# CITY PLANNING COMMISSION

- APPLICATION:
1. Negative Declaration
  2. Rezone vacant 10.4± acres from Garden Apartment (R-2B-PUD) to Townhouse (R-1A) (Sec. 13).
  3. Tentative Map to resubdivide 10.4 vacant acres into 81 zero lot line single family lots;
  4. Special Permit to construct 81 zero lot line units (Sec. 7-C).

LOCATION: West side of Truxel Road, 500 feet north of San Juan Road

APPLC. NO. 84-075

TENTATIVE MAP of  
RESUBDIVISION of LOTS 4 and 12 THRU 26 of  
RESUBDIVISION of VILLA SAN JUAN CONDOMINIUMS (150 B.M. 12)

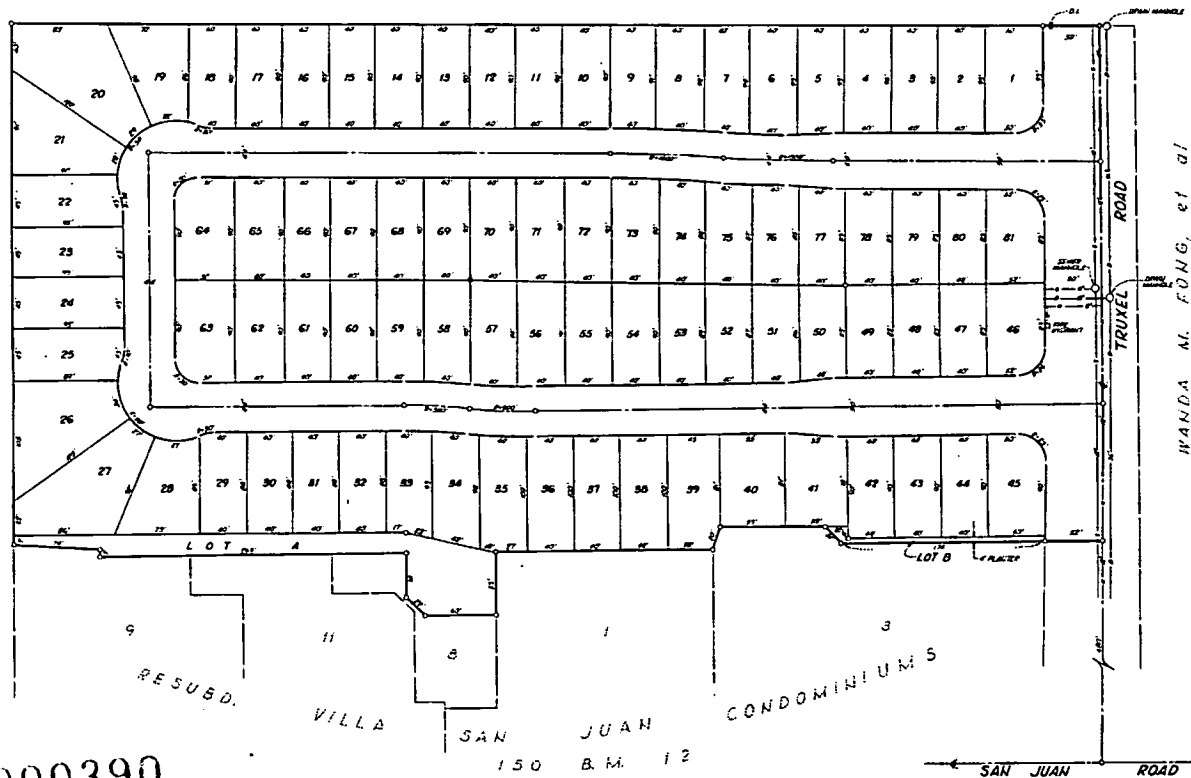
- j. Show existing water line easement on lot 27. Extend water line up to and connect with water line in the proposed street;
- k. Relocate lot line between lots 27 and 28 to coincide with the existing water line.

1. The proposed project provides an adequate range of unit sizes (750 to 1,250 s.f.) and elevations (3 for each of 4 models).
2. The resubdivision of the northerly portion of the original 20 acres modifies the on-site circulation of the original condo development. A turnaround will need to be provided to insure adequate fire access. The specific details of the turnaround can be resolved with the Fire Department prior to recordation of the map.

3. Lots A and B are remainder lots that will become part of the condo site. Staff requests that these lots be combined with the condominium site.
4. County Health indicates the zero lot line projects can have noise problems from mechanical equipment. Thus, there is a need for quiet units with sound shielding to comply with the noise ordinance.

- h. Provide easements for existing SMUD utilities;
- i. Complete a lot line adjustment process to merge parcels A and B with the condominium common property to the south;
- j. Show existing water line easement on lot 27. Extend water line up to and connect with water line in the proposed street;
- k. Relocate lot line between lots 27 and 28 to coincide with the existing water line;
- l. A turnaround shall be provided on the adjacent condominium site on the south to insure adequate access and turnaround for fire trucks to the satisfaction of the Fire Department prior to recordation of the final map.
